Docket Item # 11  
BAR CASE # 2009-0171

BAR Meeting  
September 16, 2009

**ISSUE:** Addition and Alterations  
**APPLICANT:** Nancy Pierce by Karen Becker  
**LOCATION:** 100 Queen Street  
**ZONE:** CD / Commercial

The applicant is requesting approval of a Certificate of Appropriateness for a rooftop cupola addition at 100 Queen Street.

Figure 5. Proposed roof plan.

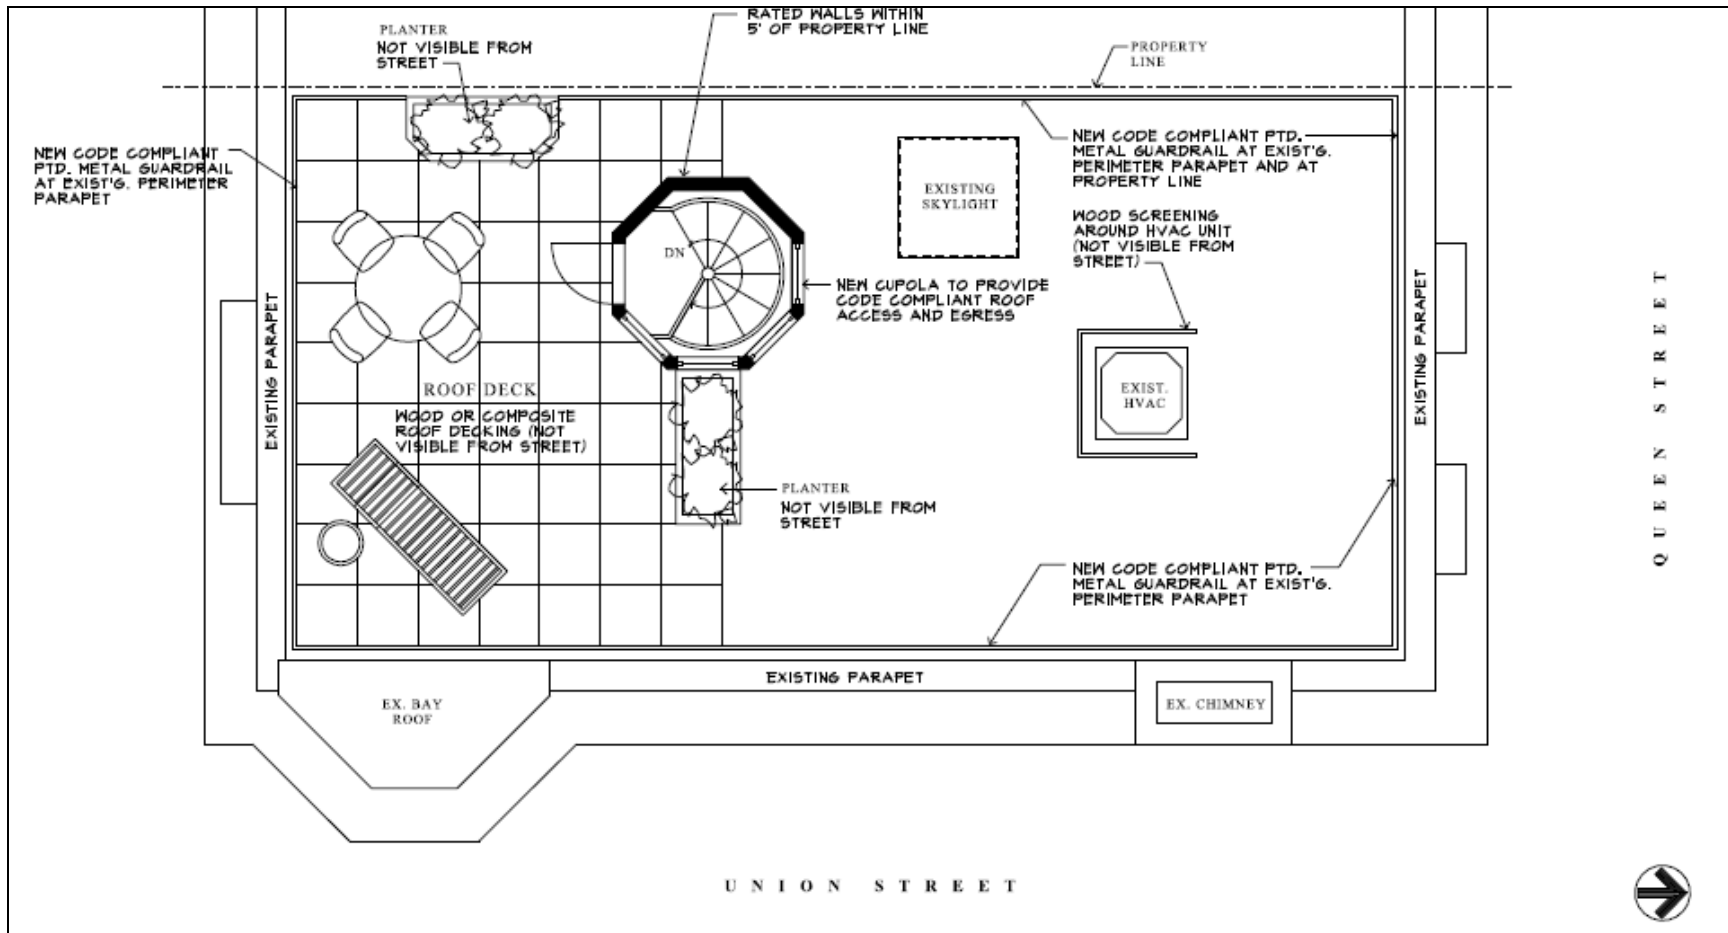
The *Design Guidelines* note that “...railings should be appropriate to the historic style of the structure,” and “should be made of materials which are sympathetic to the building materials generally found in the district. Iron cresting was a common decorative element along the rooftops of Second Empire buildings. While the proposed metal railing is somewhat more substantial than was typical of such rooftop cresting, the railing is an appropriate element for the architectural style of this building. Staff has determined that neither the decking nor the planter boxes will be visible from the public right-of-way. As such, Staff has no objections to the proposed railing, decking and planter boxes as proposed.

Figure 8. Proposed cupola.

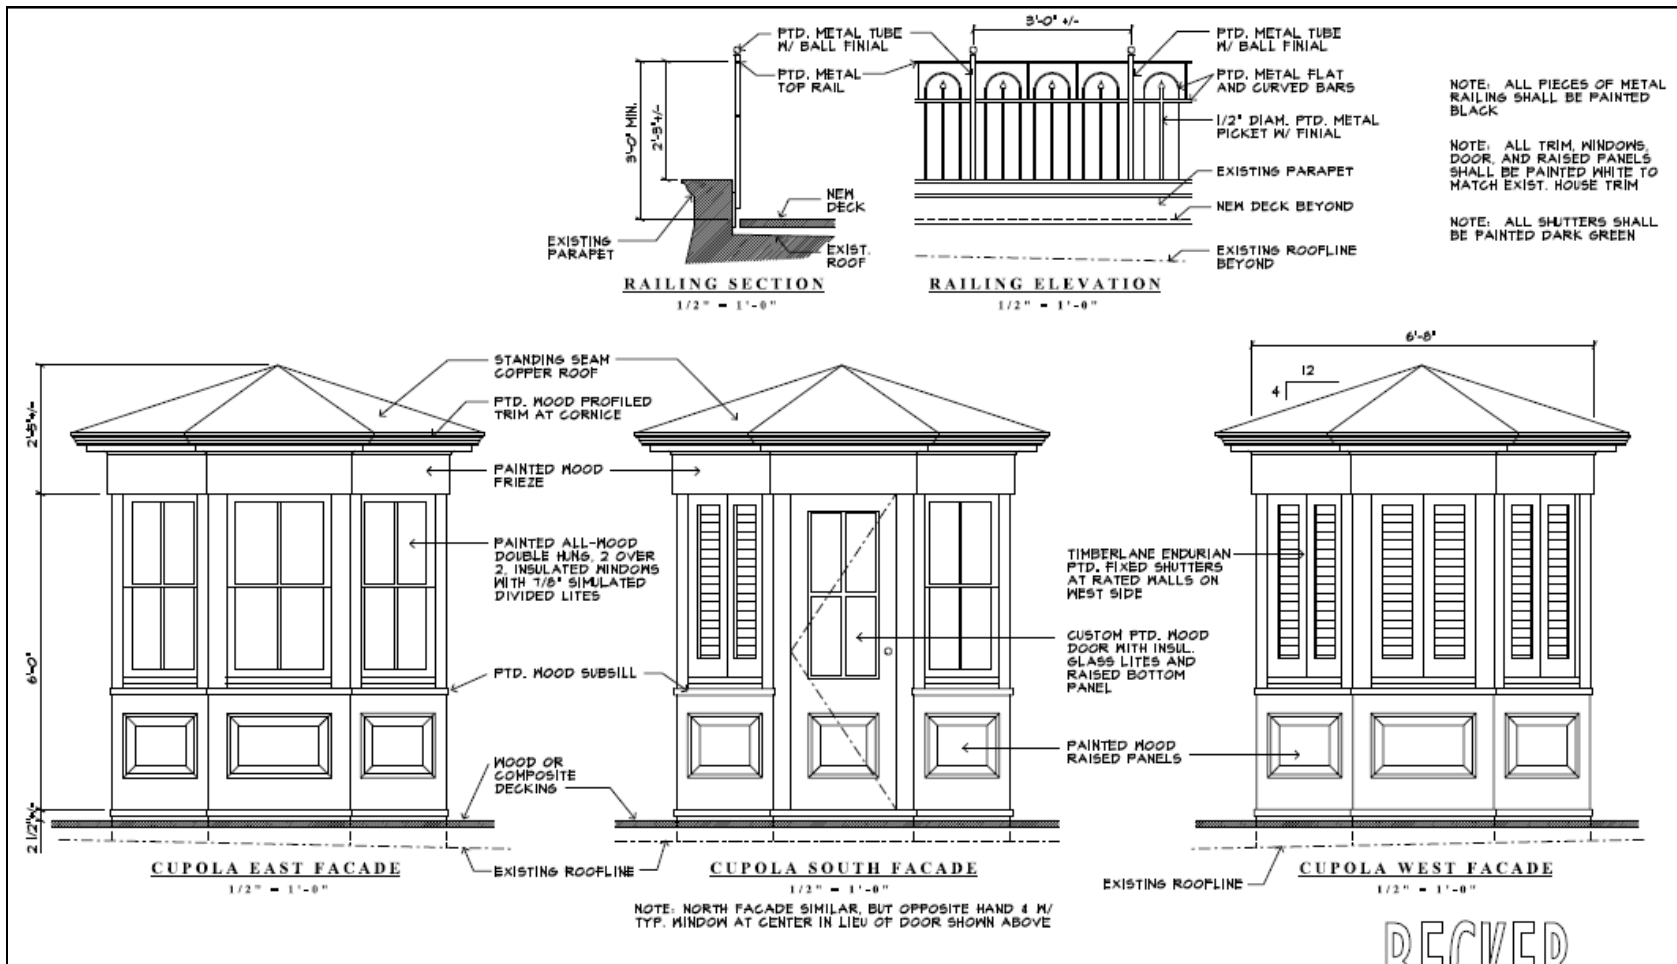
In the opinion of Staff, the proposed rooftop cupola addition is appropriate and compatible with the three-story townhouse at 100 Queen Street and conforms to the *Design Guidelines* for additions. The *Design Guidelines* advise that "the stylistic characteristics of additions to residential buildings should reflect the historical architectural styles found within the historic

districts.” Furthermore, “additions must be designed so that they are compatible with both the architectural character of the existing house and the immediate neighborhood.” The proposed rooftop addition will have minimal impact on the existing non-historic townhouse. The scale, mass, and architectural style of the cupola is appropriate and consistent with the style and character of the existing townhouse. The applicant has supplied drawings illustrating site lines from both Queen and Union streets. The site lines indicate that the cupola will have minimal visibility from the public right-of-way. However, the structure will be more clearly visible from Founders Park.

The proposed materials are generally appropriate. Regarding materials, the *Guidelines* for residential additions advise that “building materials for residential additions should reflect these traditional materials,” in reference to the predominance of wood and brick in the historic districts. Painted wood trim, wood windows and a standing seam copper roof are appropriate for this rooftop cupola. On a case-by-case basis, the Board has approved composite materials, such as HardiePlank and wood composite shutters, as well as synthetic materials, such as Fypon and Azek, on additions and new construction. For synthetic materials, if appropriate as proposed, Staff recommends that they be solid-through-the-core and paintable. The applicant has clarified with the manufacturer that the shutters are a solid proprietary cellular PVC and come with an applied urethane paint that can be repainted in the future. The proposed synthetic shutter will be minimally, if at all, visible from the public right-of-way. Therefore, Staff supports the proposed materials for the cupola.
